**MONTGOMERY COUNTY HISTORIC PRESERVATION COMMISSION**  
**STAFF REPORT**

<b>Address:</b>	17 West Kirke Street, Chevy Chase	<b>Meeting Date:</b>	3/20/2024
<b>Resource:</b>	Contributing Resource <b>Chevy Chase Village Historic District</b>	<b>Report Date:</b>	3/13/2024
<b>Applicant:</b>	Chuck Muckenfuss & Angela Lancaster (Dustin Hirt, Architect)	<b>Public Notice:</b>	3/6/2024
<b>Review:</b>	Historic Area Work Permit	<b>Tax Credit:</b>	Partial
<b>Case Number:</b>	1060991	<b>Staff:</b>	Dan Bruechert
<b>Proposal:</b>	Partial deck and rear elevation demolition, construction of new elevator shaft, new pergola, fenestration and other alterations.

**STAFF RECOMMENDATION**

2 PROPOSED EXTERIOR ELEVATION  
 A100 SCALE: 3/16" = 1'-0" (REAR)

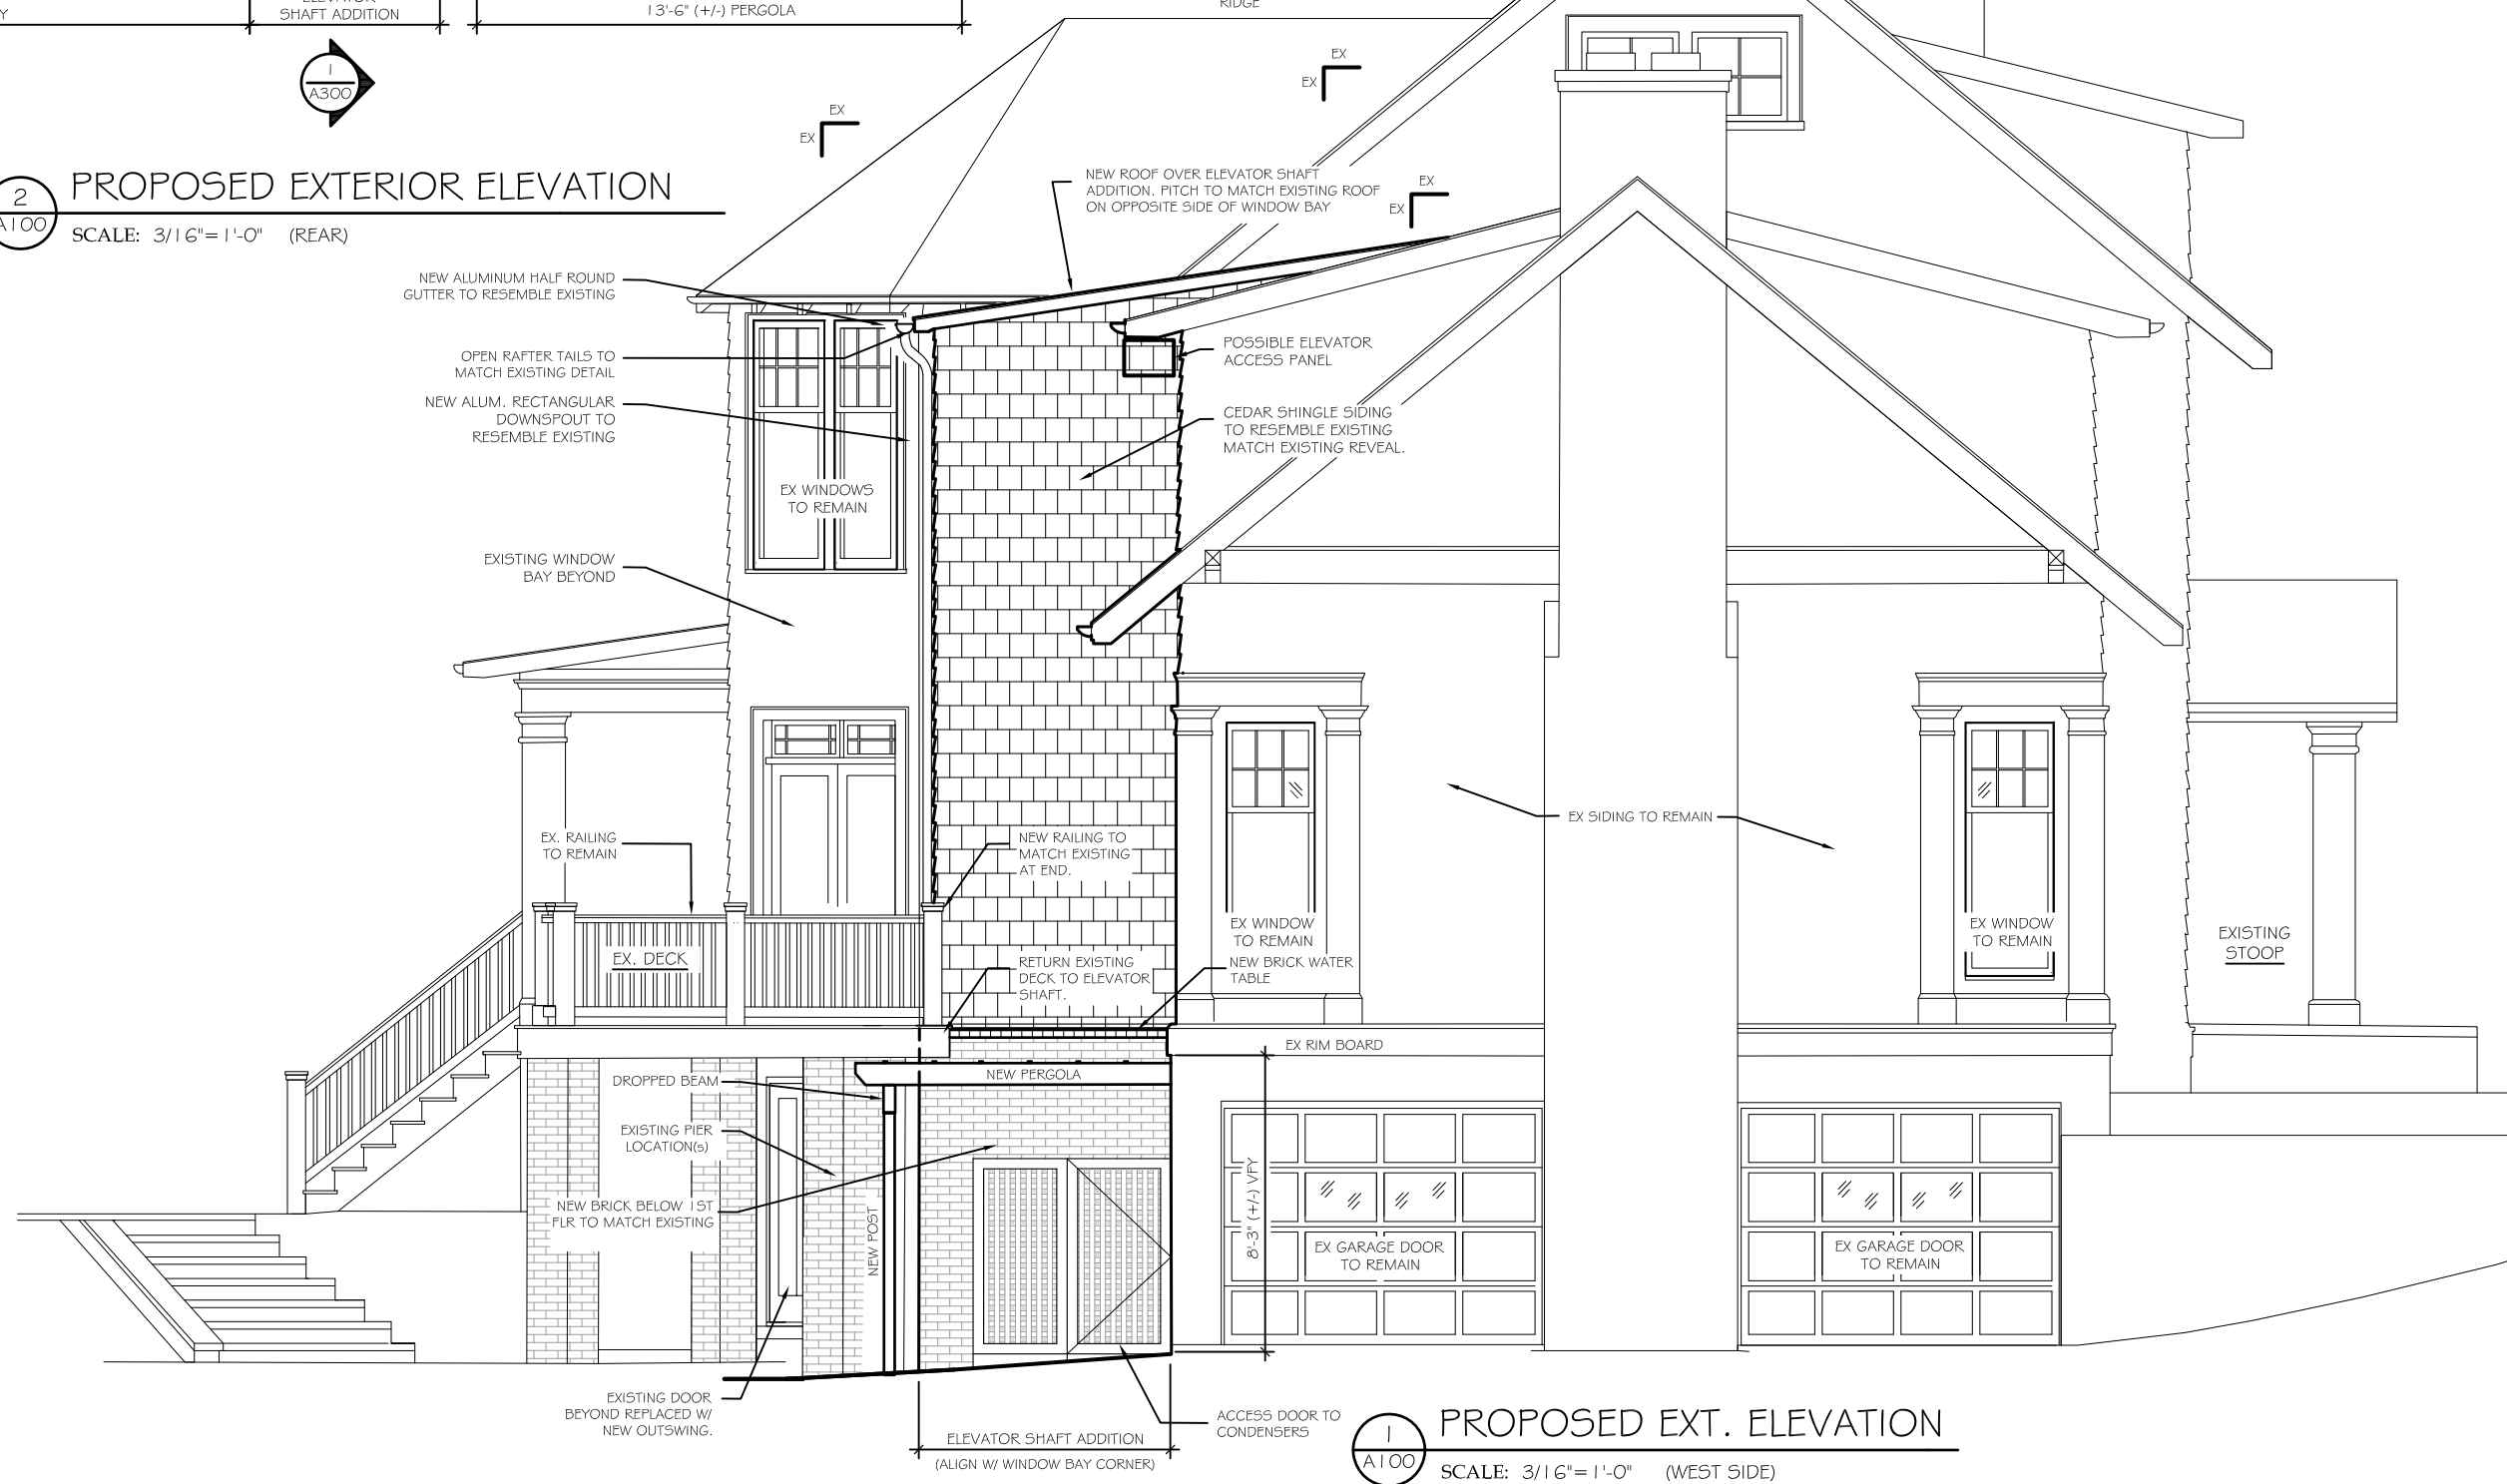
At the rear of the house, the applicant proposes to construct an exterior elevator tower. The tower will provide access to all three floors. The exterior of the elevator tower has a brick foundation, with cedar shake siding on the second and third floors. The applicant proposes to install a wood Marvin six-over-one sash window on the first and second stories of the rear elevation. The glazing for the windows will be tempered, as required for code, but the grille profile was not provided, and the only description for the windows is, “SDL-Resembling existing.” The tower roof will be asphalt shingles or a membrane roof. Dimensions for the proposed tower were not noted on the drawings, however, Staff estimates the tower measures 5’ × 7’ (five feet wide, by seven feet deep) and does not reach the ridge of the 1991 addition. The drawings note that the gutters will match the existing and the rafter tails will match the existing. Non-historic windows on the 1991 addition will be removed to accommodate the elevator tower. Because of its location, the elevator tower will not be visible from the public right-of-way.

The *Design Guidelines* state that alterations to properties that are not at all visible from the right-of-way should be subject to a very lenient review. Staff finds the size of the proposed elevator tower will not overwhelm the character of the house. Staff additionally finds the proposed materials (i.e., brick foundation, cedar shake siding, and wood windows) are all consistent with the historic house and its non-historic addition. However, Staff notes the general requirement for multi-light windows is that they have permanently affixed exterior and interior grilles with a spacer bar. Staff recommends the HPC add a condition to the approval of this HAWP that the proposed windows satisfy this condition, and the final approval authority delegated to Staff to verify the condition has been met. Additionally, Staff finds matching the gutters and rafter tail detail is an appropriate treatment, but notes that the submission does not include a material specification nor is the drawing detailed enough to evaluate how closely these details will match the existing construction. Staff recommends the HPC include a condition that the final permit set of documents includes a specification for the gutter and a detailed drawing showing the treatment of the rafter tails. Staff finds both shingle and membrane roofing are appropriate in this application because the roof will not be at all visible. Staff recommends the HPC approve the elevator tower under the *Design Guidelines*, 24A-(b)(2) and (d), and Standards 2, 9, and 10.

Figure 4: Partial rear elevation showing the proposed elevator tower (circled).

The proposed wood pergola measures approximately 8' (eight feet) and is 12' × 8' (twelve feet wide, by eight feet deep). Staff finds the size of the pergola does not overwhelm the rear of the house (see Figure 4, above), and that wood is the appropriate material for a feature of this type. Staff finds the pergola is compatible with the character of the house and surrounding district and recommends the HPC approve its construction under the *Design Guidelines*, 24A-8(b)(2) and (d), and Standards 2, 9, and 10.

2. Gutter specifications for the elevator tower shall be submitted to Staff for review and approval before issuing the final HAWP. Final approval authority to determine that the gutters are compatible with the existing construction is delegated to Staff.

3. Detailed construction drawings showing the rafter tail detail of the elevator tower shall be submitted to Staff for review and approval before issuing the final HAWP. Final approval authority to determine that the detail sufficiently matches the existing construction is delegated to Staff.
